BRUNSWICK STEAM ELECTRIC PLANT, UNIT NOS. 1 AND 2
DOCKET NOS. 50-325 AND 50-324/LICENSE NOS. DPR-71 AND DPR-62
RESPONSE TO REQUEST FOR ADDITIONAL INFORMATION REGARDING
REQUEST FOR LICENSE AMENDMENTS - EXTENDED POWER UPRATE
(NRC TAC NOS. MB2700 AND MB2701)

Response to Request for Additional Information (RAI) 14

Response to Request for Additional Information (RAI) 14

Figure 1 - BSEP Design Basis LOCA Short-term Containment Pressure Response

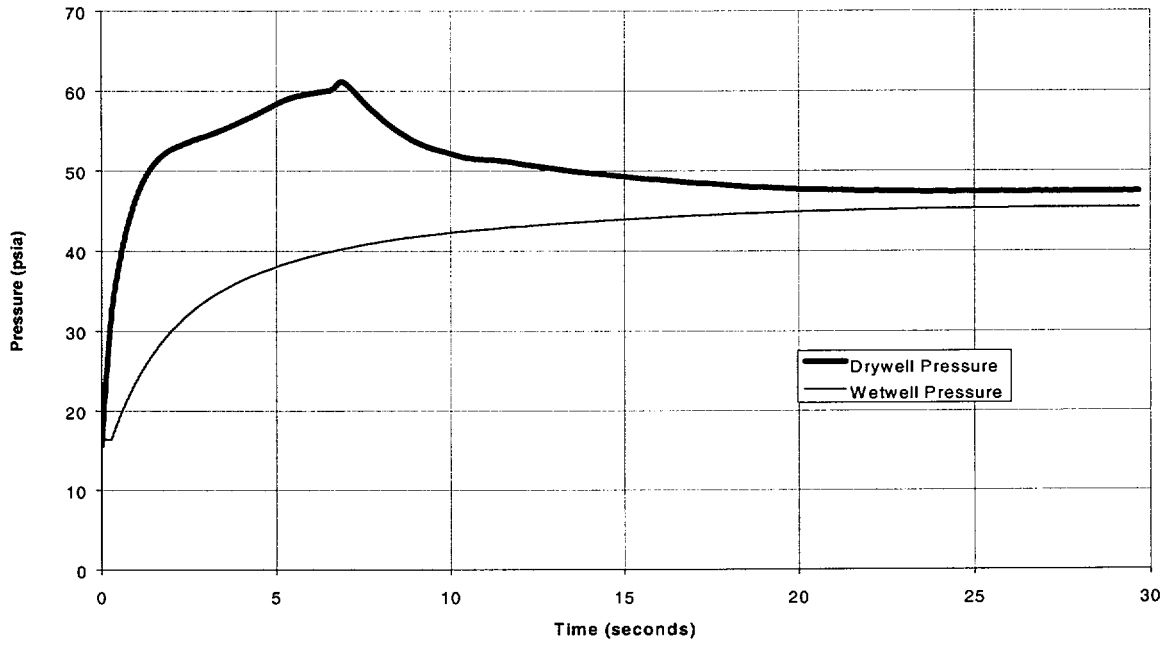
Please provide the peak pressure and temperature curves for the EPU analyses. (PUSAR Table 4-1 provides the peak values for DBA-LOCA.).

The design basis Loss-of-Coolant Accident (LOCA) containment responses are plotted in Figures 1 through 4. Figures 1 and 2 provide the short-term responses, which determine peak drywell pressure and temperature. Figures 3 and 4 provide the long-term responses, which determine the peak wetwell airspace and suppression pool temperatures; as well as the wetwell secondary peak pressure.

Figure 5 - BSEP 0.75 ft² Steam Line Break Containment Temperature Response

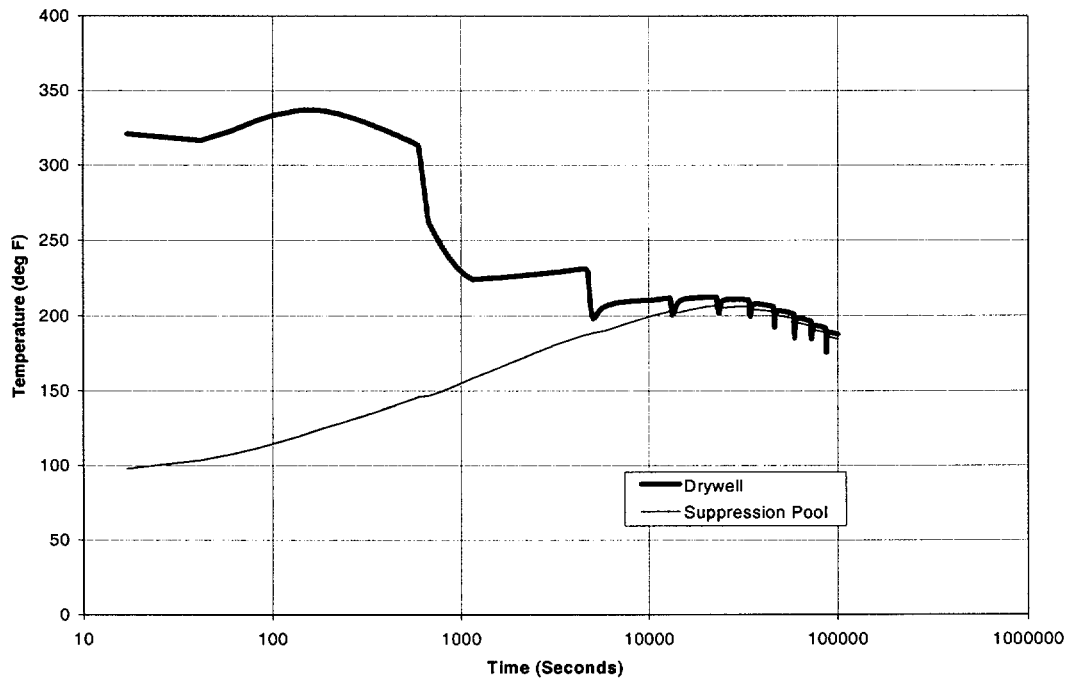
Please provide the peak temperature values for steam line breaks and wetwell pressure for NPSH evaluation.

For the EPU evaluation, four steam line break sizes were analyzed: 0.01 ft², 0.1 ft², 0.3 ft², and 0.75 ft². Figure 5 shows the drywell and suppression pool temperature responses to the 0.75 ft² steam line break, which resulted in the highest peak drywell temperature of 338.1°F among the four break sizes. The wetwell pressure response is plotted in Figure 6.

Figure 7 - Uncontrolled Drywell Hydrogen and Oxygen Concentrations for EPU

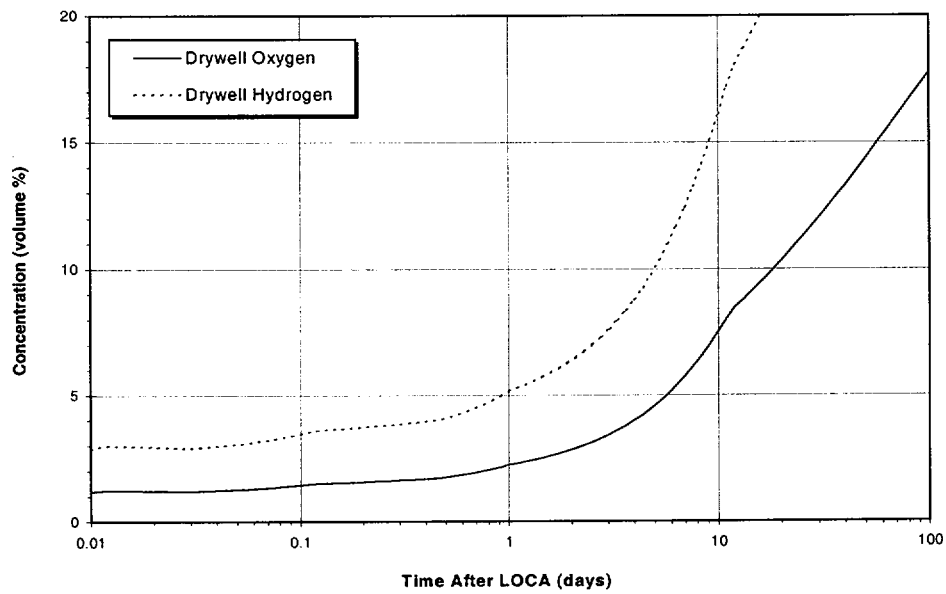
For Post-LOCA Combustible Gas Control in Section 4.7, please provide the hydrogen and oxygen concentration curves following a LOCA,

Figures 7 and 8 provide the requested curves.
